Appendix E – Hydrology and Water Quality Supporting Information

Subject: Peer Review of Select Hydrology and Water Quality Technical Analyses from the Z-Best Project Applicant

RE: RESPONSE TO “MEMORANDUM: FURTHER CLARIFICATION OF HYDROLOGY AND SUPPLY ANALYSES AND THE GROUNDWATER DRAWDOWN EVALUATION”

TITLE
PROPOSED DETENTION BASIN 1 - PLAN AND SECTION

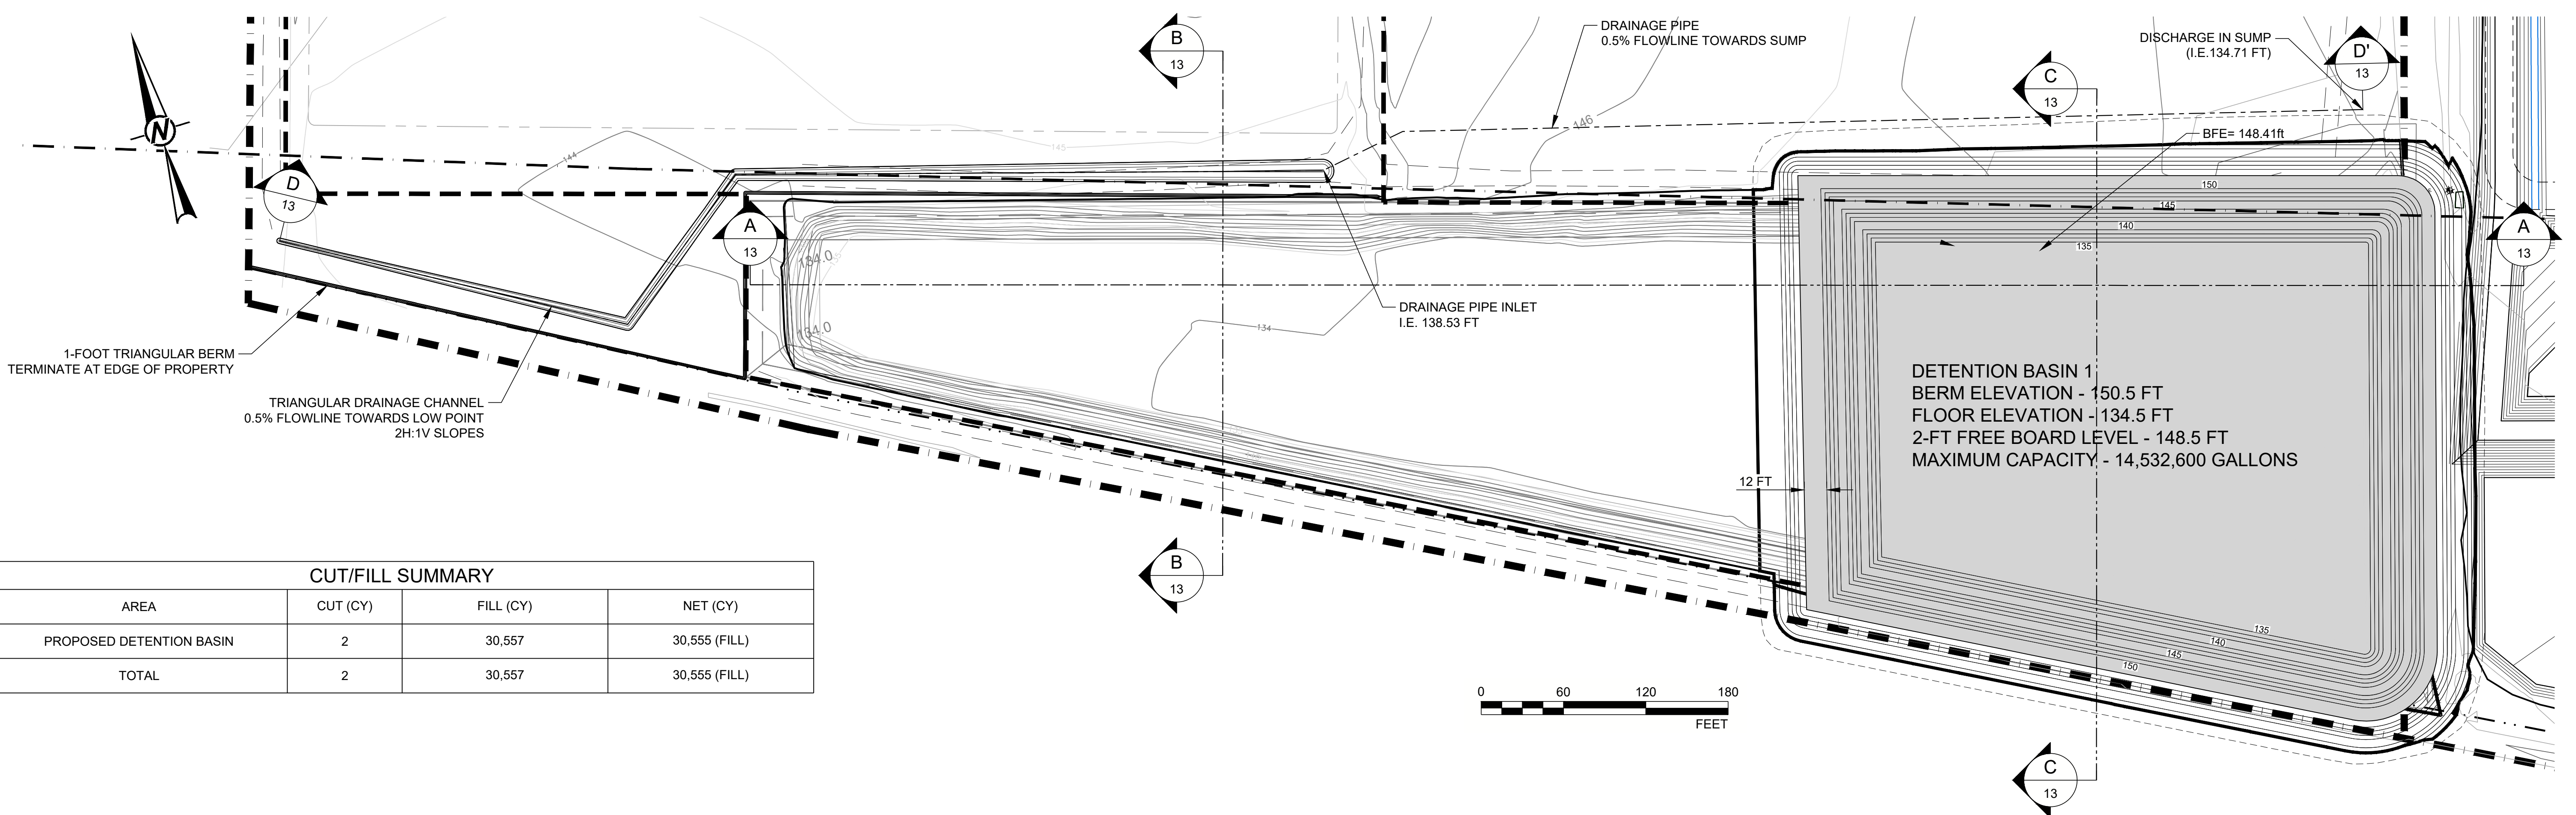
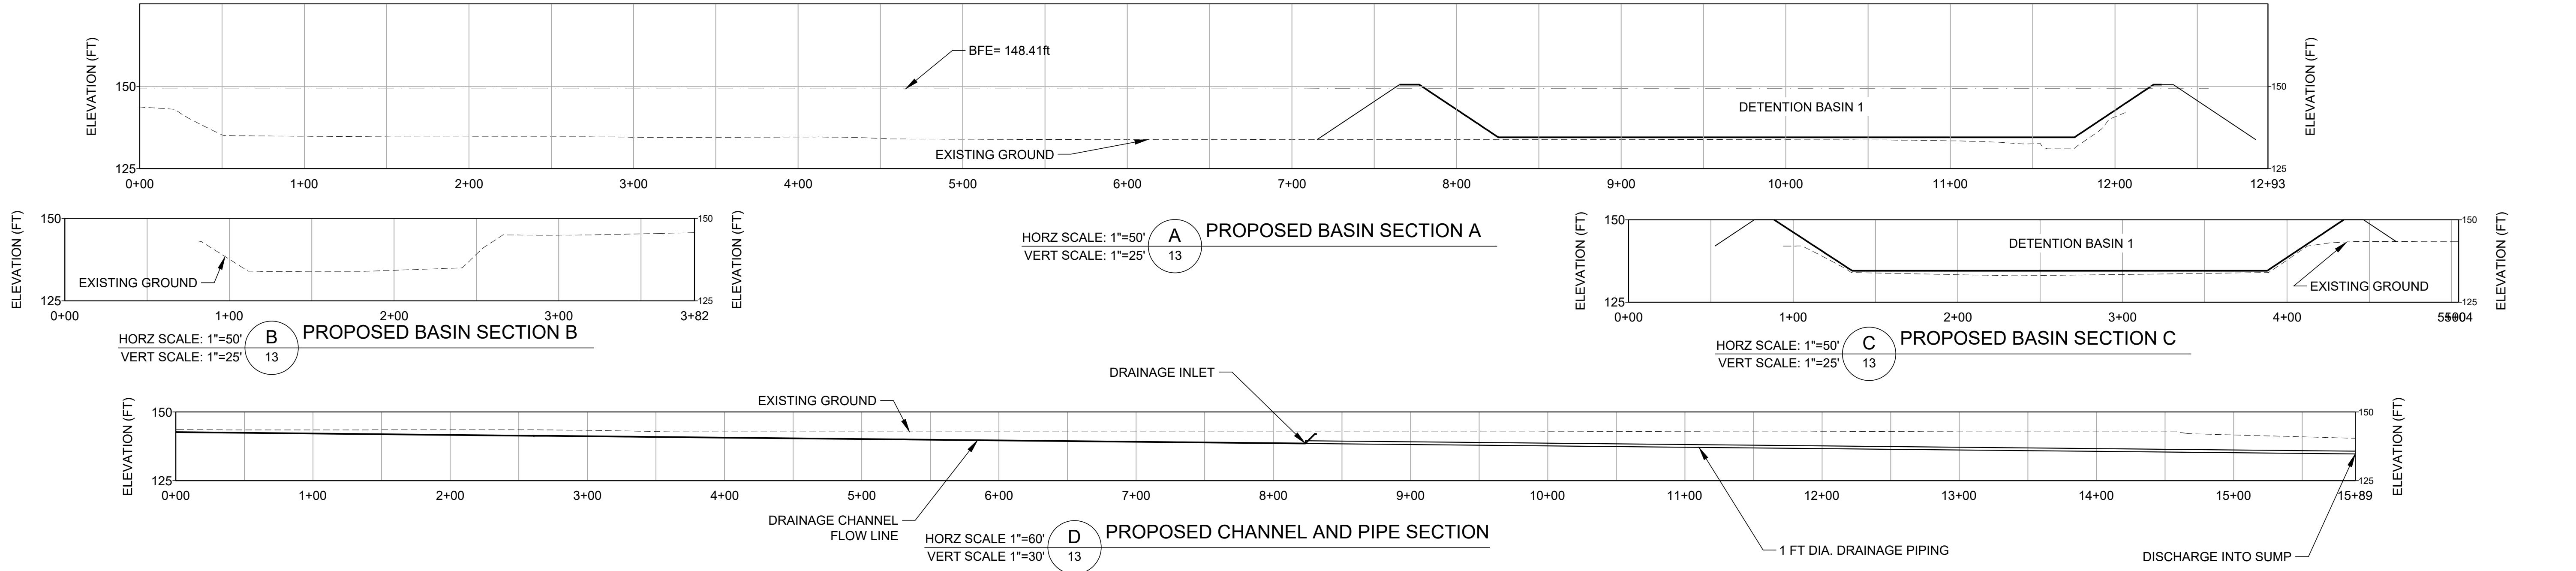
- 5. The Golder memo mentions a drainage ditch to be constructed along the north side of the western portion of Detention Basin #1, which does not appear to be shown on the project plans. Please provide an updated Drawing 13 showing the location and contours of the proposed drainage ditch and provide north-south sections through the western and eastern portions of the detention basin showing both existing and proposed ground surfaces. Please also update Proposed Basin Section A on Drawing 13 to show the proposed ground surface on the outer slopes of the Detention Basin #1 berms, which are currently missing from the section.*

A revised drawing 13 is attached.

FIGURE 1-11
CROSS SECTION B-B'
 LLAGAS BASIN GROUNDWATER MODEL
 SANTA CLARA VALLEY DISTRICT

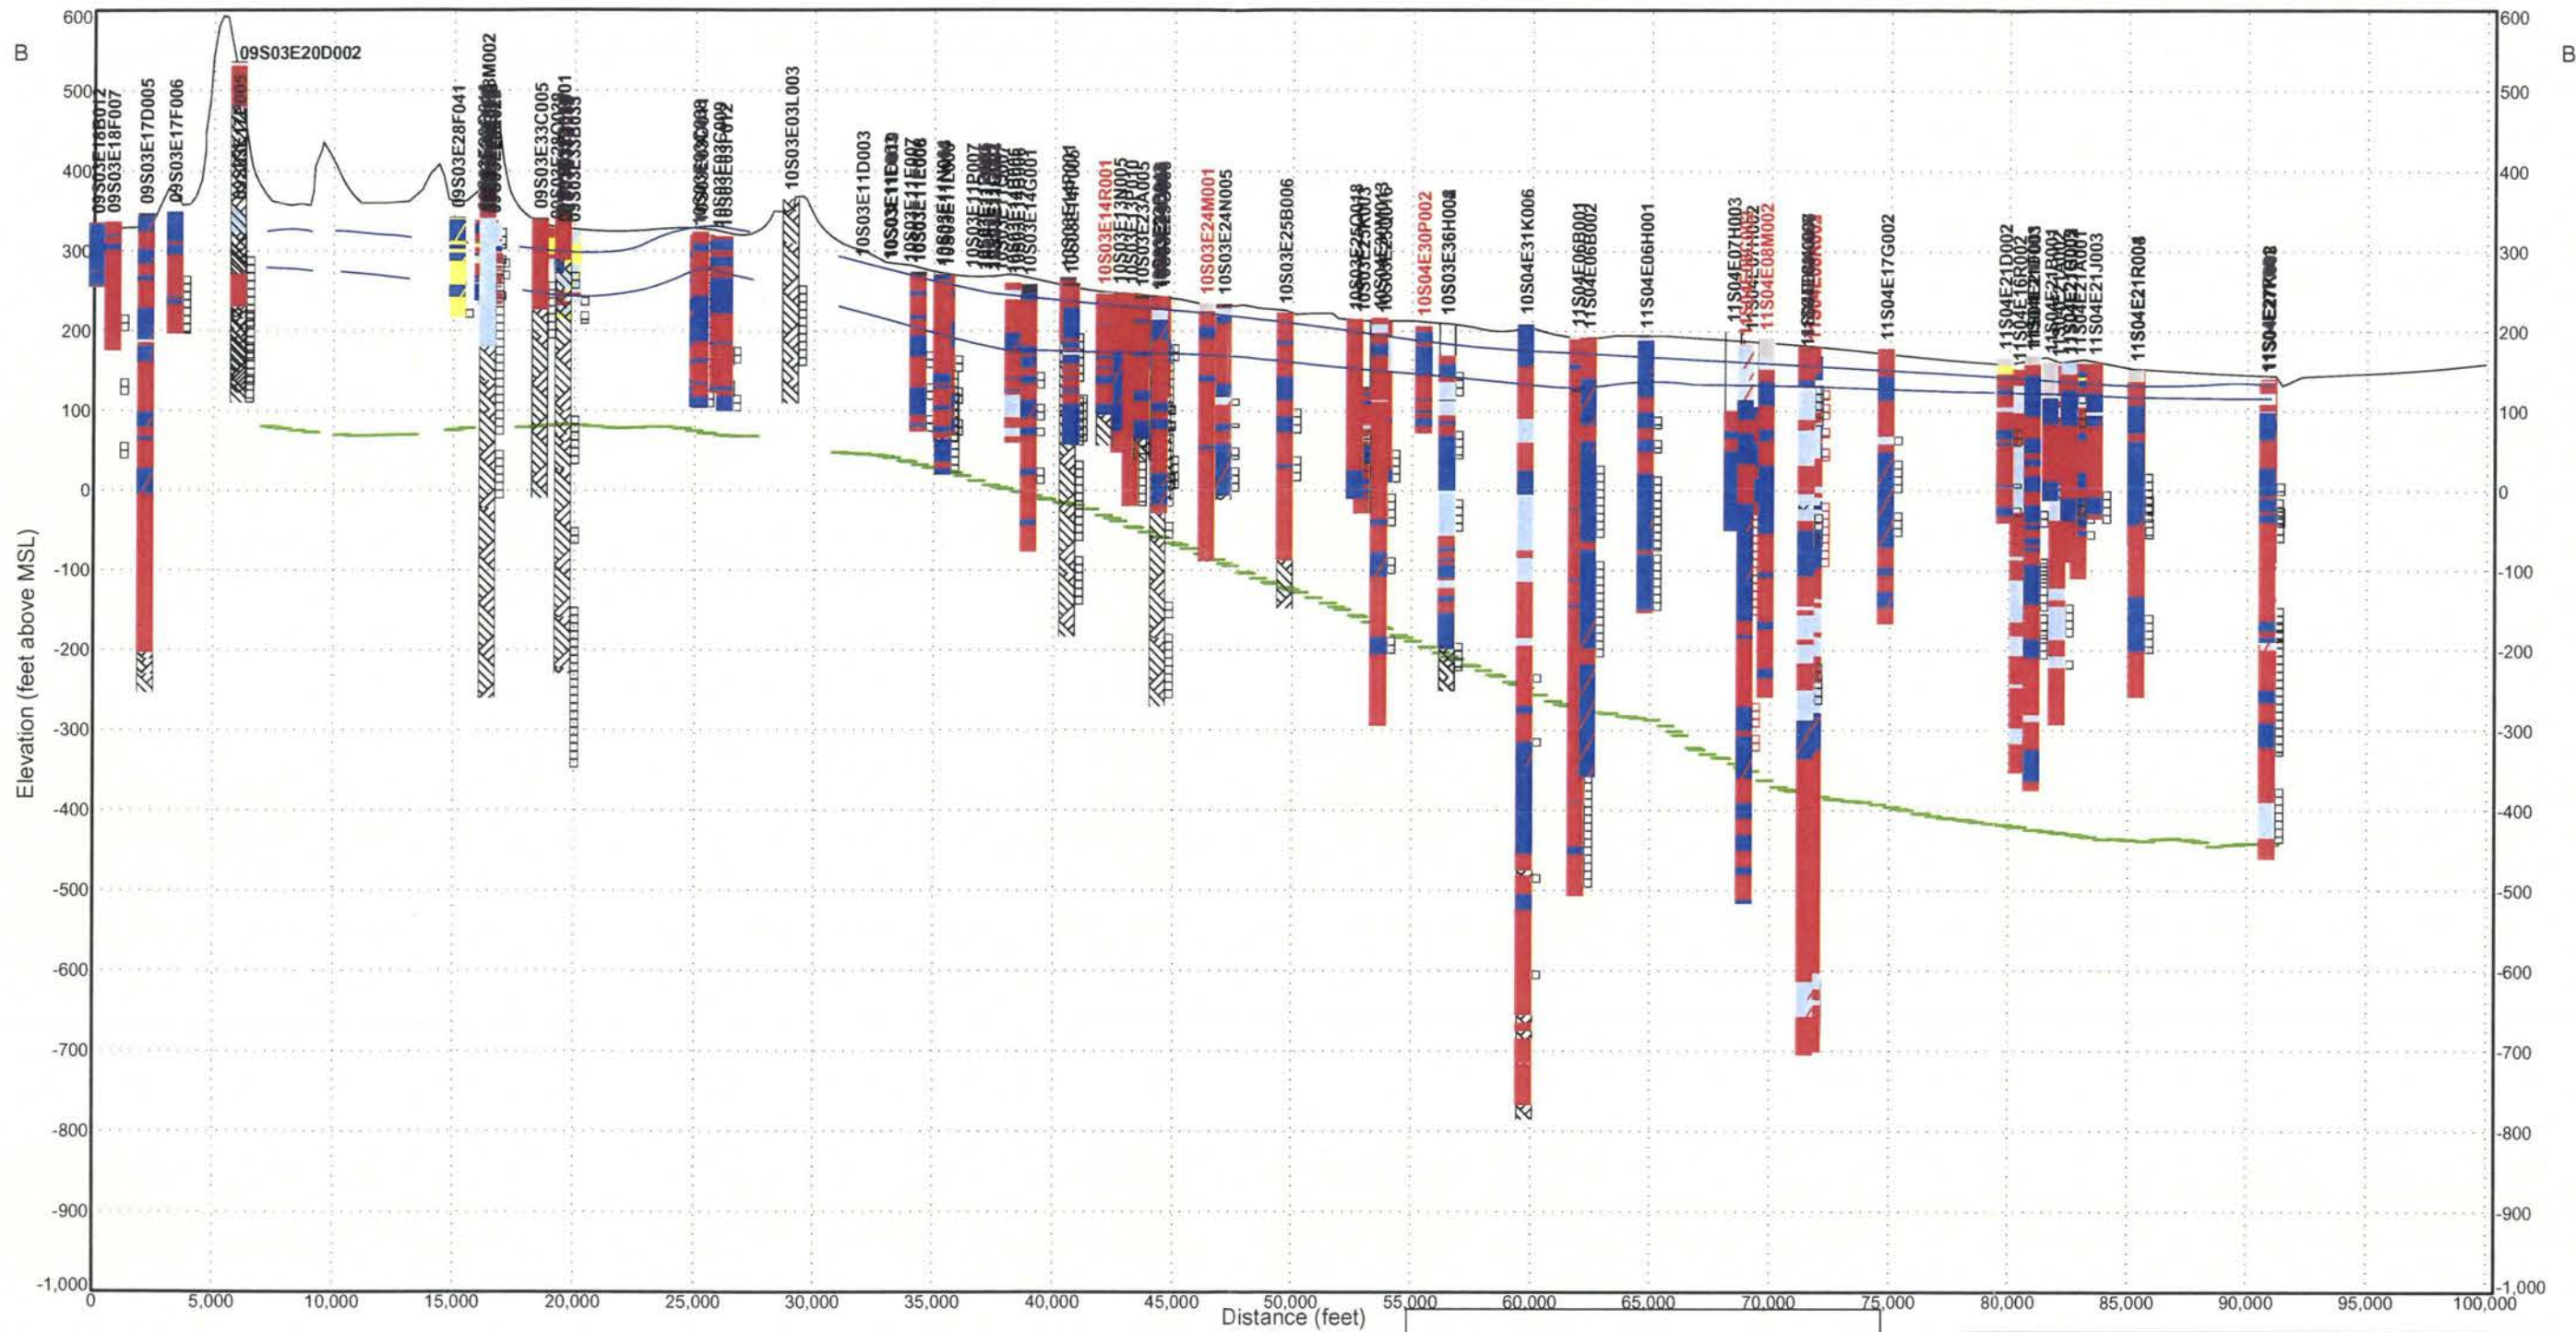
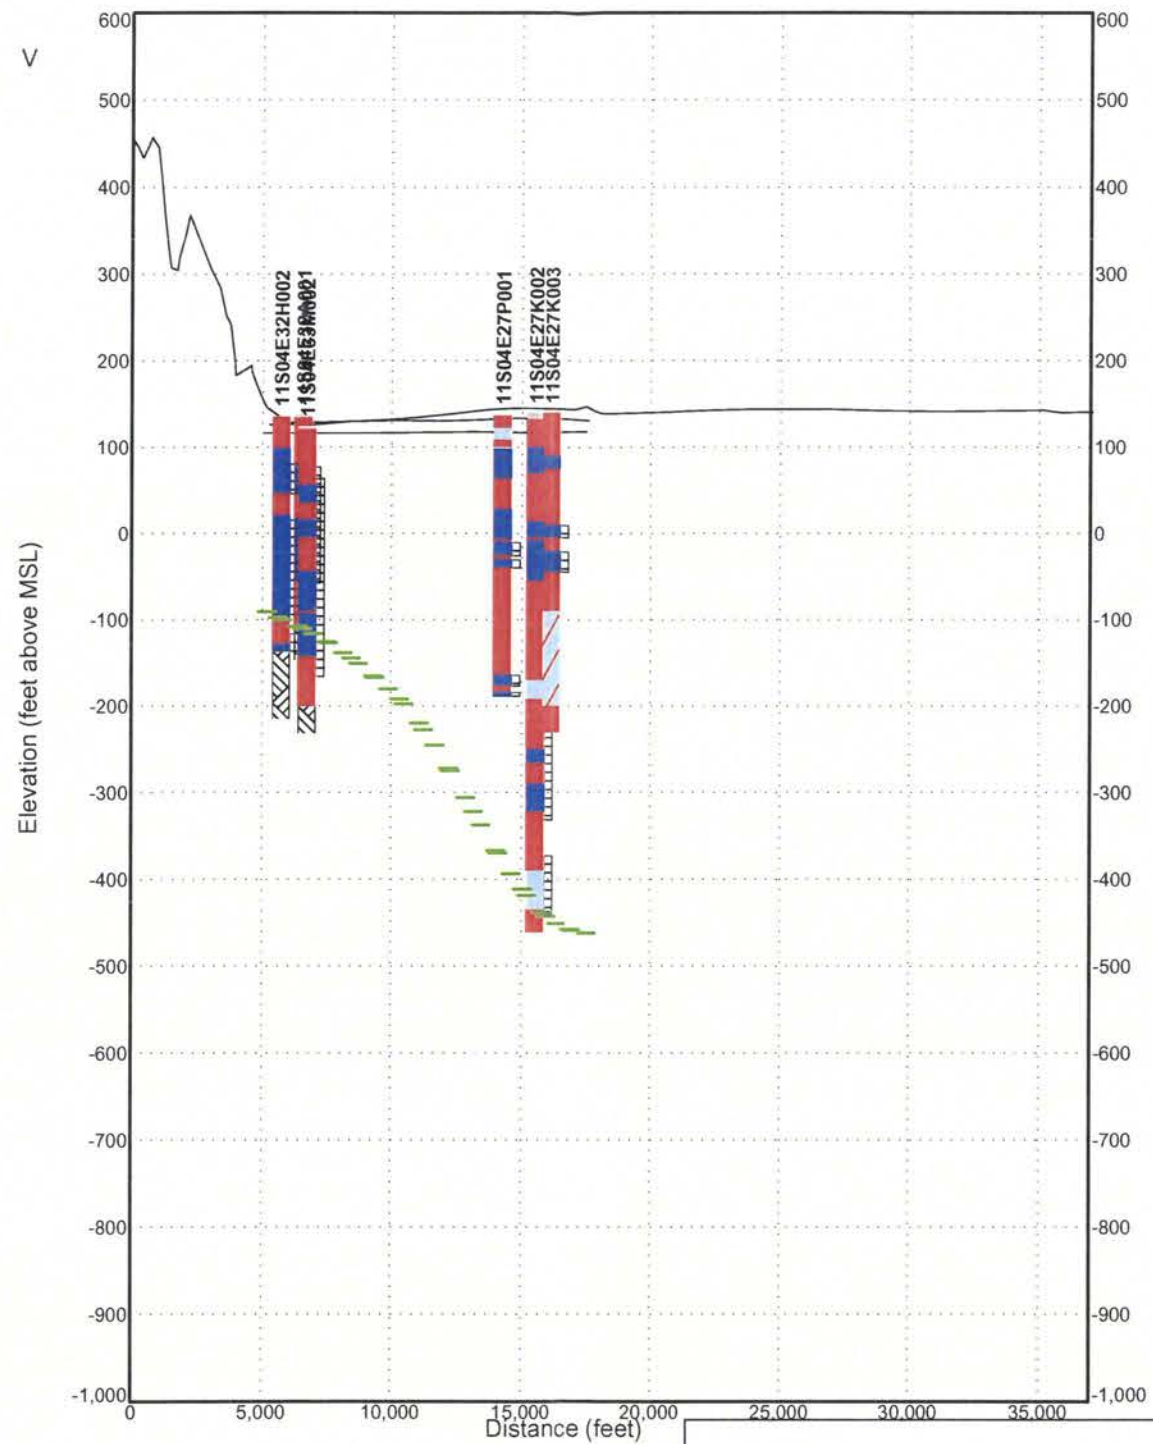
Comment 4: **Provide drawdown estimates for the river distance.** The Golder groundwater drawdown evaluation memo (August 26, 2022) provides estimated drawdown at offsite wells. Because the Pajaro River is also a sensitive receptor, the estimated drawdown at the closes riverine location should also be provided. **It is recommended that Golder revise their August 26, 2022 memo to include the estimated drawdown for the closest riverine location to the well.**

Response: Golder disagrees with this recommendation. As shown in the well log for Main Aquifer Well, the top of screened interval is at 160 feet below ground surface (bgs). The well log also shows thick clay layers above the screened interval at 135 to 148 bgs, 90 to 110 feet bgs and 13 to 48 feet bgs. Attached with this memo, are two cross sections from the report titled *Llagas Basin Numerical Groundwater Model*, prepared for Santa Clara Valley Water District by CH2M Hill and dated May 2005. The cross sections, oriented roughly north to south and west to east, show two thick continuous clay layers located at depths above the reported screened interval for Main Aquifer Well that extend to the bank of the river (i.e., the model boundary). Further, as observed in well logs reviewed by Golder, the uppermost clay layer extends from the base of a thin (typically less than 3 feet thick) surficial topsoil layer to a depth below the bottom of the river. These data suggest a separation from the upper unconfined zone that includes the river and the deeper confined zones in which the Main Agriculture Well is screened. Therefore, it is highly unlikely that Main Agricultural Well is in hydraulic communication with the river.

An additional consideration is that the Theis method and Driscoll's approximation used to calculate the drawdown are based on confined aquifer conditions. The use of the Theis method for calculating drawdown in an unconfined receptor would be inappropriate. Based on these factors, no changes are proposed for the revised memorandum with respect to Comment 4.
